TRANS/WP.29/GRSG/2003/3
5 February 2003

PROPOSAL FOR DRAFT AMENDMENT TO REGULATION No. 43
(Safety Glazing)

Transmitted by the Expert from the European Commission (EC)

“Safety glazing having a regular light transmittance < 40 per cent

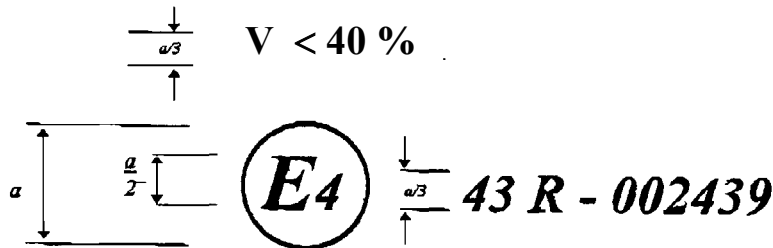
Annex 2A, add after the approval mark a new example for safety glazing having a regular light transmittance < 40 per cent, to read:

a = 8 mm min.

The above approval mark affixed to a safety glazing with a regular light transmittance of less than 40 per cent as determined by the test described in annex 3, paragraph 9.1., shows that the component concerned has been approved in the Netherlands (E 4) pursuant to Regulation No. 43 in its original form under approval No. 002439. The approval number indicates that the approval was granted in accordance with the requirements of Regulation No. 43”
